Proposal for the 04 series of amendments to UN Regulation No. 129

Submitted by the expert from the European Association of Automotive Suppliers

The text reproduced below was prepared by the expert from the European Association of Automotive Suppliers (CLEPA) to include booster cushion category into the scope of UN Regulation No. 129. The document contains the modifications from document WP.29-GRSP-2018-29 and document GRSP-64-15.

Figure 1
Sitting height check measurement device

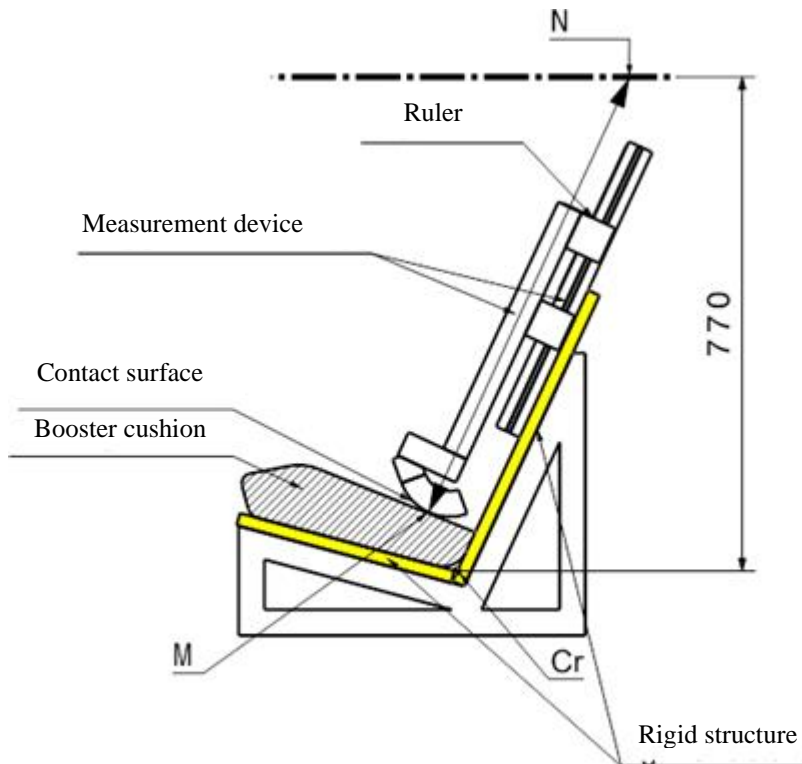
"6.1.3.6 For booster cushions, type approval shall not be granted for a stature below 125 cm. Booster cushions shall not be declared for use below a stature of 125 cm.

Booster cushions shall ensure that the top of the child's head is at or above a horizontal plane at 770 mm vertically from Cr when seated on the test bench described in Annex 6.

The procedure to check if a booster cushion fulfils this requirement is outlined as follows (See figure 1 below):

- (a) A rigid mock-up of the test bench, as defined in Annex 25, is used for this check. The mock-up shall have the same geometry as the R129 test bench with enough rigidity. For the rest of the text the mock-up is called simulated test bench.

- (b) A rigid structure is attached to the simulated test bench and holds a sliding part. A horizontal plane that is located at a vertical distance of 770 mm from Cr is defined.

- (c) The booster cushion shall be placed on the simulated test bench with its centreline aligned with the centreline of the test bench and the rear surface of the booster cushion contacting the backrest of the test bench.

- (d) If ISOFIX attachments are present these shall be latched with the test bench lower ISOFIX anchorages. An additional force of 135 +/-15N shall be applied in a plane parallel to the surface of the simulated test bench. The force shall be applied along the centreline of the Enhanced Child Restraint System and at a height of no more than 100 mm above the simulated test bench seat surface.

- (e) The measurement device is extended downwards parallel to the simulated test bench backrest, until it is stopped by the booster seat cushion.

Figure 2
Ruler of measurement device:

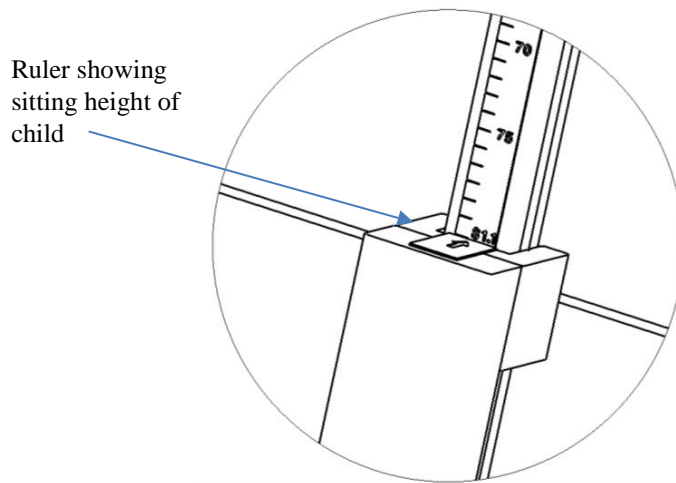
Delete Figure 2

Insert new Figure 2

- (f) The measured distance between the two points M and N represents the sitting height of a child who will use the cushion represented in Figure 1. The corresponding value is displayed by a ruler that is provided with the device as shown in Figure 12.
- (g) Using the data in Table 3, the sitting height is utilized to determine the corresponding minimum stature of the child that can be accommodated by the booster cushion. Example: A sitting height of 70,2 cm shall correspond to a child minimum stature of 125 cm; a sitting height of 81,1 cm shall correspond to 150 cm.

In case the value obtained for the sitting height is between two integer values always round up to the next integer value (e.g. Measured sitting height = 72,9 cm ► resulting stature = 132.25 cm ► Smallest stature allowed = 133cm)

- (h) The stature determined in this procedure shall be compared to the lower limit of the approval stature range. The requirement is fulfilled if the lower approval stature is greater or equal than the obtained minimum stature.

Figure 2A
Door panel geometry for testing integral ECRS with ISOFIX—side view (tolerance general: ± 2 mm and ± 1 degree)

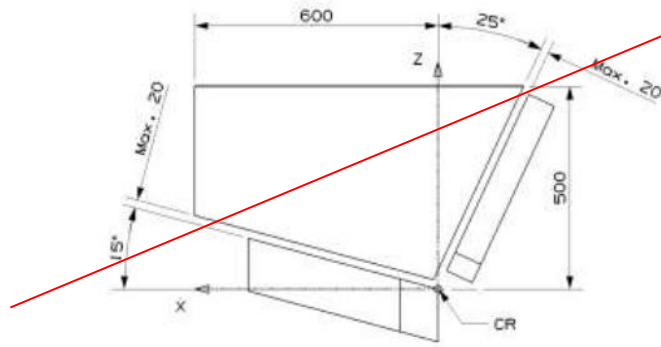
Paragraph 1, Figure 2, shall be deleted

Insert new figures 2A and 2b, to read:

~~This door panel shall be used when the Integral ECRS under test is installed with ISOFIX.~~

3. The 01 series of amendments to UN Regulation No. 129 amended the door panel geometry to create a small opening, close to the seat bight. This was done to protect the panel from interaction with the anchorage of the adult seat belt on the test bench (which would be added later in the 02 series). Integral ISOFIX Enhanced Child Restraint Systems (ECRS) were also required to use this new door panel geometry, despite the belt not being used for these ECRS.

4. This proposal amends the 02 series of amendments (and all the following series) to UN Regulation No. 129 to require Integral ISOFIX ECRS to use the original door panel geometry with no opening (except during extensions of approvals in which the new panel geometry was used).

Figure 2B
Door panel geometry for testing non-integral ECRS—side view (tolerance general: ± 2 mm and ± 1 degree)

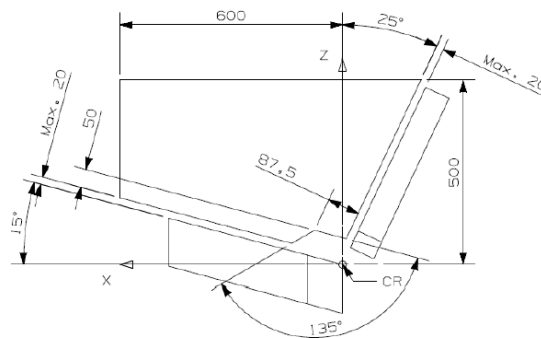
~~This door panel shall be used when the ECRS under test is installed with the adult seat belt.~~

~~Tests to extend the type approval of Integral ISOFIX ECRS may also use this door, provided it was used for the original type approval.~~

5. The proposal will ensure that ISOFIX ECRS designs cannot use the opening to mitigate loads to the ECRS and dummy. Integral belted and non-integral ECRS will continue to use the panel with an opening.

Measurement device for booster cushion height check

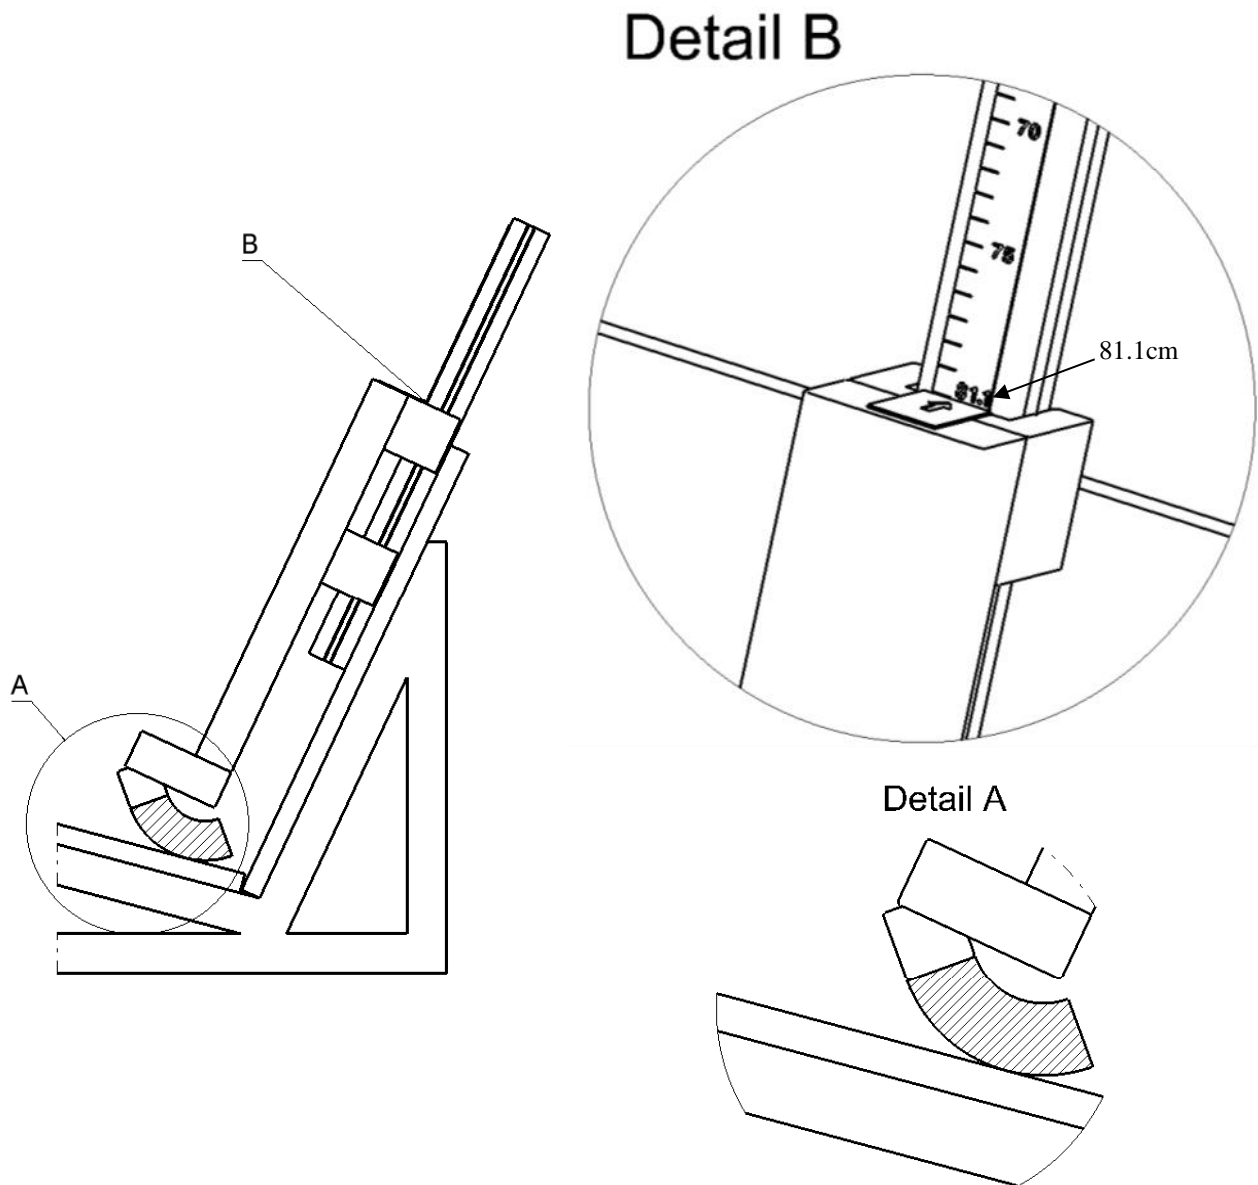
The mass of the device shall be 15kg +/-1kg

Calibration of the measurement scale

The calibration of the ruler is based on an idealized measurement in Computer-Aided design (CAD) using the frame of the measurement device on the rigid test bench simulating R129 test bench and a digital Q10 dummy. The dummy is raised so that its head is aligned with the horizontal bar at 770 mm and its back is in contact with the

backrest of the test bench. In this position the distance from the dummy's bottom to the seat cushion of the test bench is measured. This distance is added to the sitting height of the digital Q10 and the result is the calibration value. In our case the value is 81,1 cm.

To calibrate the ruler of the measurement device its structure has to contact the supporting surface (Detail A). In this configuration the scale has to show the calibration value – 81,1 cm (Detail B).

Manikin block (based on truncated P10)

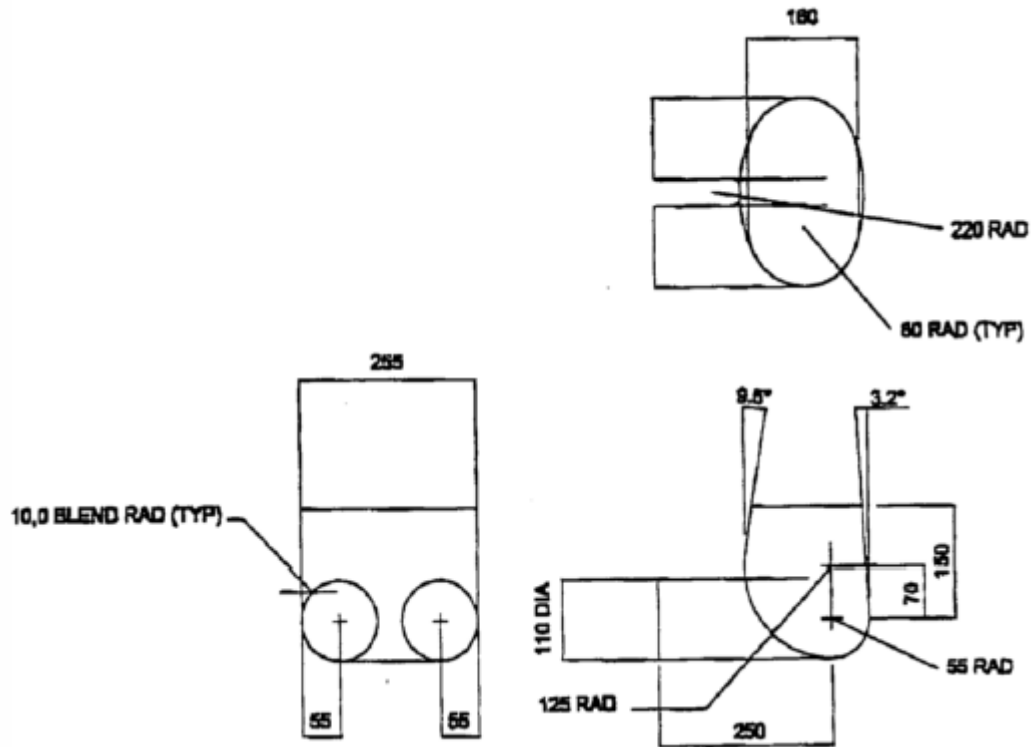
Place a cotton cloth on the seating surface of the test bench. Position the booster cushion on the test bench, position the lower torso body block as described in Annex 26, Figure 1, on the seating surface, fit and apply the 3-point adult safety-belt and tension as prescribed in paragraph 7.1.3.5.2.2. With a piece of 25 mm width webbing or similar tied round the booster, apply a load of 250 ± 5 N in the direction of arrow A, see Annex 26, Figure 2, in line with the seating surface of the test bench.

Material: Expanded polystyrene (EPS) (40 to 45 g/l)

Booster pull test using manikin block

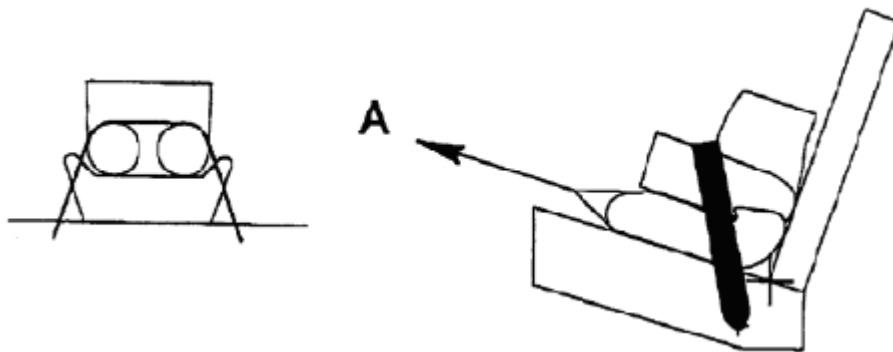
It should not be allowed that the booster cushion is completely pulled out under the lower torso body block."
